CALGARY SUBDIVISION

APPLICATION NUMBER 3 DATE June 19, 2014

REQUEST Subdivision

DETAIL SITE PLAN

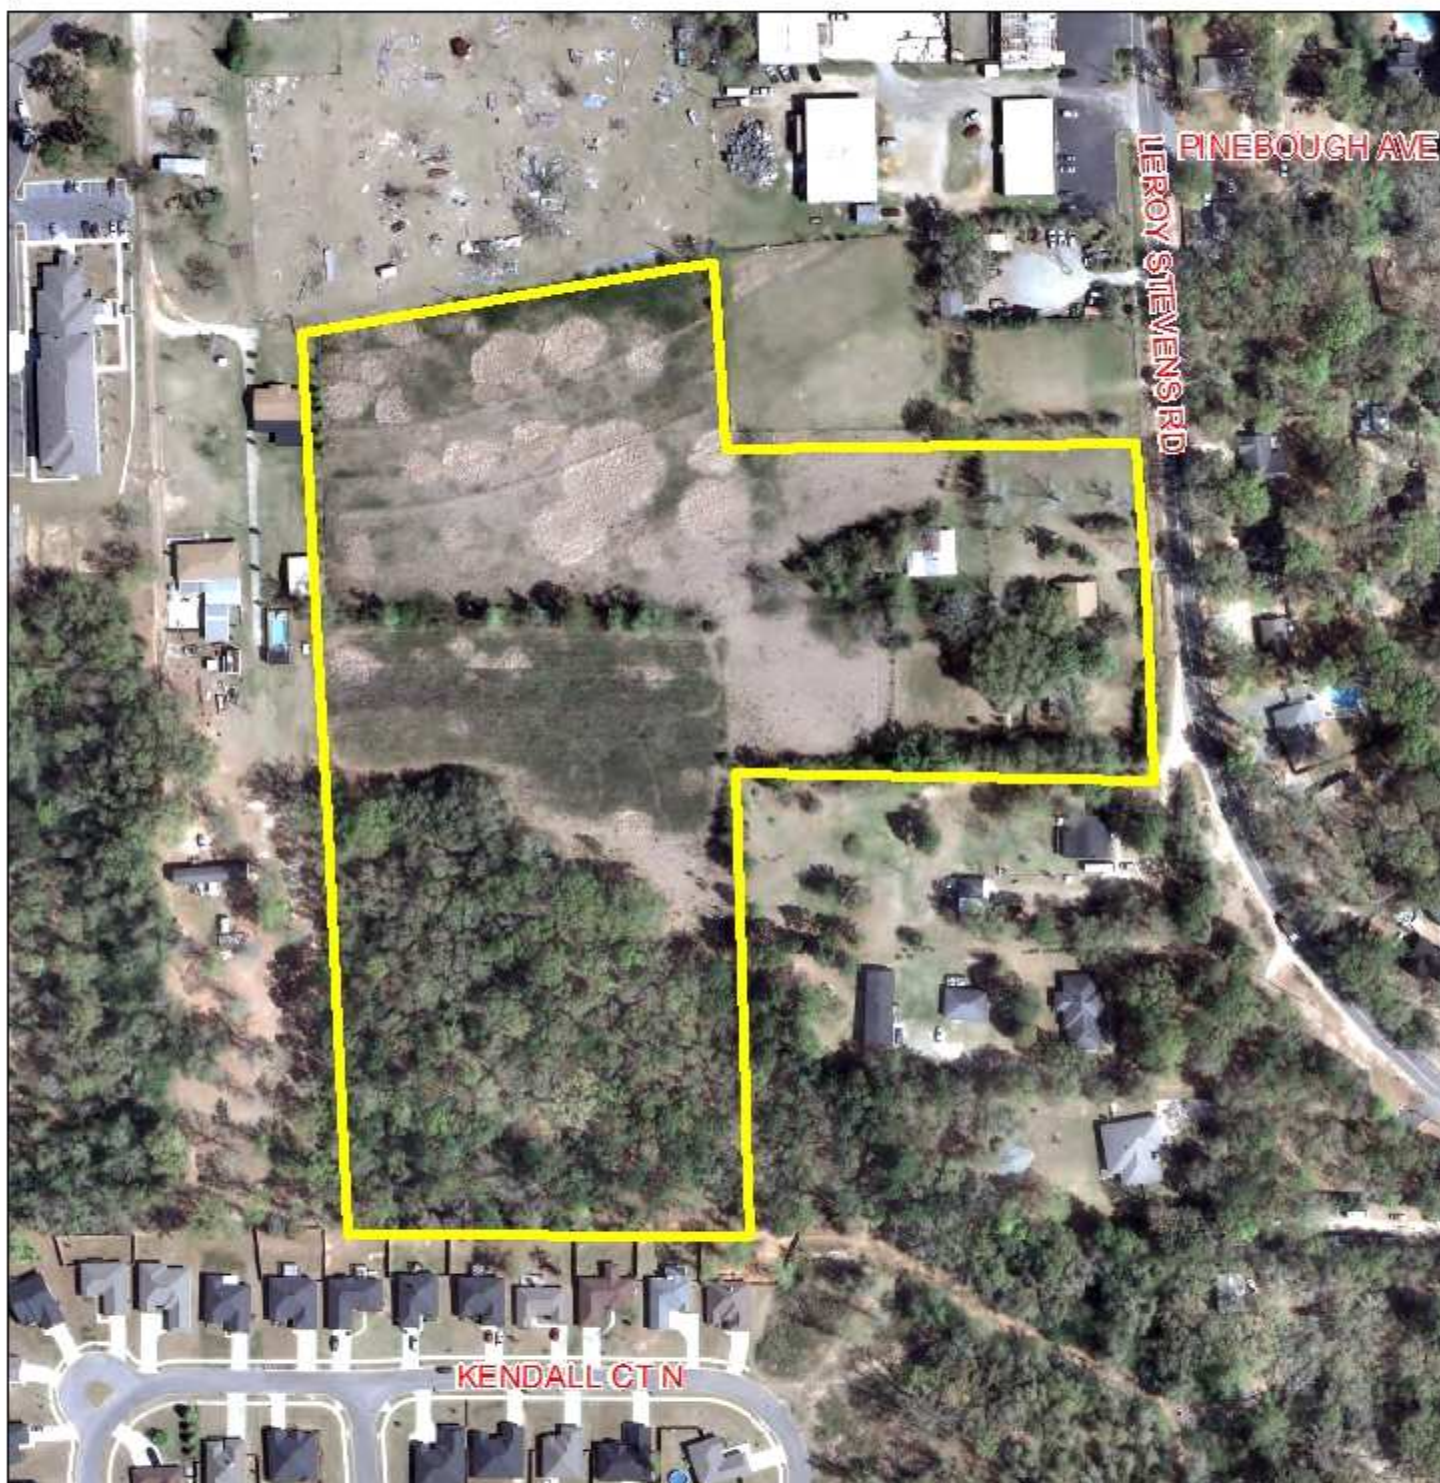
The proposed subdivision fronts Leroy Stevens Road, a minor street without curb and gutter. As the right-of-way is compliant with Section V.B.14. of the Subdivision Regulations, no dedication should be required. The right-of-way width of both proposed streets within the subdivision is 50', which is also compliant with the above section of the Subdivision Regulations.

The preliminary plat illustrates the construction of two new, unnamed streets. It should be pointed out that the cul-de-sacs at the terminus of each street are illustrated with a 55' radius and proposed 110' diameter, instead of 120', as required in Section V.B.14. of the Subdivision Regulations. If approved, the Final Plat should be revised to reflect compliance with the previous section of the Subdivision Regulations regarding turnaround right-of-way diameter.

It should be noted that the site contains numerous easements which are illustrated on the preliminary plat and a 1.24 ± acre common area, located along the southern lot line of the proposed Lots 16-18 and accessed by a 20' ingress/egress access easement. If approved, notes should be placed on the Final Plat stating that no permanent structures can be constructed in any easement and all common and detention areas shall be maintained by the property owners.

The preliminary plat illustrates a 30' minimum building setback line for all proposed lots within the subdivision, which exceeds the Subdivision Regulations' requirement, and a 25' minimum building setback line along Leroy Stevens Road for the proposed Lots 1 and 26, which meets minimum requirements. Also, all proposed lots appear to exceed the minimum size requirements as the lot size is illustrated in both square feet and acres and should be retained on the Final Plat, adjusted for any required dedication, if approved.

- 1) Revision of the Final Plat to depict the turnarounds at the terminus of both proposed streets in compliance with Section V.B.14. of the Subdivision Regulations;*

- 2) Retention of the lot size information in square feet and acres on the Final Plat;*
- 3) Retention of the 30' and 25' minimum building setback line on the Final Plat;*

- 4) Placement of a note on the Final Plat stating that no permanent structures can be constructed in any easement;*
- 5) Placement of a note on the Final Plat stating that all common and detention areas shall be maintained by the property owners;*
